Staff Summary Report

Development Review Commission Date: 06/26/07 Agenda Item Number: 4

SUBJECT: Hold a public meeting for a Development Plan Review for TACO BELL located

at 1674 E. Southern Avenue.

ELEVATIONS

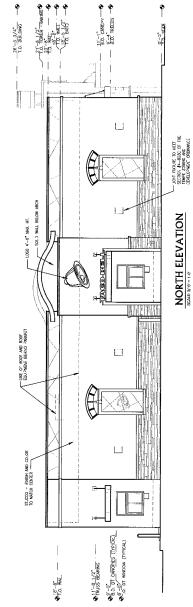
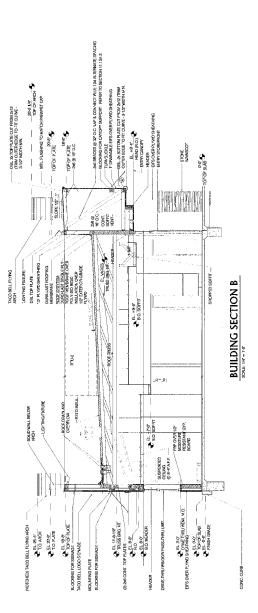
- Require that the architectural pop-out element shown on the south, north and west elevation
 be added to the east façade, to provide four sided architecture, as required by the General
 Plan of Development for this center and for aesthetic reasons. The east elevation could also
 use a faux window, although this is only a recommendation, not a condition.

- Require that the bell shown on the faux window and above the entrances be removed, these
 are sign elements which need to have separate review.
- Remove the faux window on the right side of the north elevation, and replace this with a real window into the dining room, for both aesthetic and security reasons. With all of the parking located on the north side of the building, and the only surveillance provided by the drive through window, staff determined that safety of the employees and customers would be enhanced with visual surveillance between the dining room and parking area. This would also benefit the security of the rest of the shopping center.

- Remove the arch element from the north elevation where the architectural pop-out is only 4".
 Most of the arched elements are located on top of pop out features that allow the arch to be free-standing from the building. The north side arched element conflicts with the accent band and the main body of the building.

- Remove the 6' screen wall and provide electrical and utility equipment internal to the building, not on the east façade, this is for both aesthetic and security reasons.

- 6. The architectural pop-out element shown on the south, north and west elevations shall also be added to the east façade, to provide four sided architecture, as required by the General Plan of Development for this center.

- 7. Remove the bell shown on the faux window and above the entrances, these are sign elements which need to have separate review.
- 8. Remove the faux window on the right side of the north elevation, and replace this with a real window into the dining room.

- 9. Remove the arch element from the north elevation where the architectural pop-out is only 4" and provide a continuous decorative band at the top of the building.

- 14. Remove the 6' screen wall shown on plan and elevation view. Locate the electrical service entrance section (S.E.S.) inside the building or inside a secure yard that is concealed from public view.

PRELIMINARY LANDSCAPE PLAN

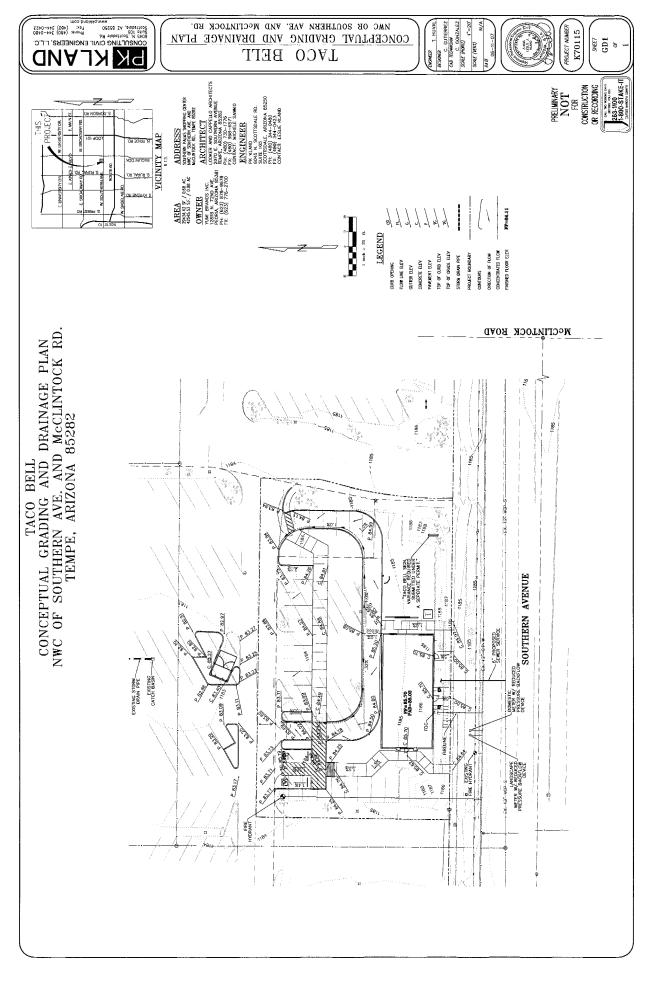
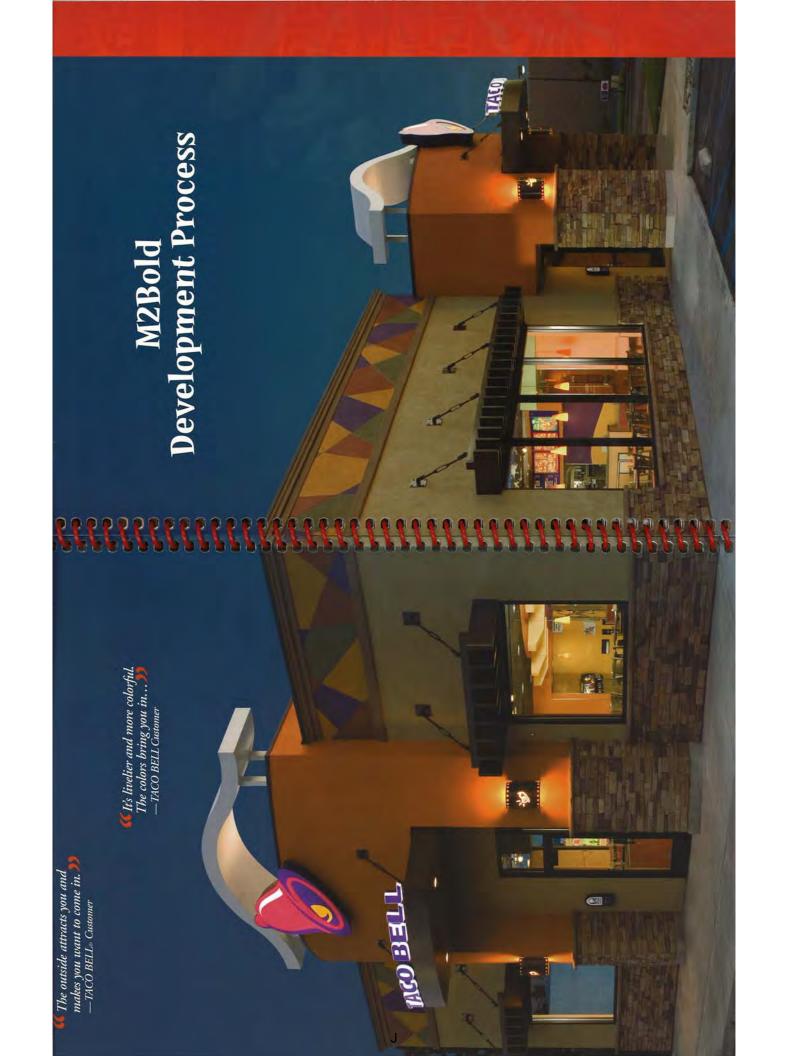
- 18. Irrigation notes:
 - a. Provide dedicated landscape water meter.
 - b. Enclose backflow prevention device in a lockable, pre-manufactured cage.
 - c. Provide pipe distribution system of buried rigid (polyvinylchloride), not flexible (polyethylene). Use of schedule 40 PVC mainline and class 315 PVC ½" feeder line is acceptable. Class 200 PVC feeder line may be used for sizes greater than ½" (if any). Provide details of water distribution system.

- 20. Top dress planting areas with a rock or decomposed granite application. Provide rock or decomposed granite of 2" uniform thickness or less. Provide pre-emergence weed control application and do not underlay rock or decomposed granite application with plastic.
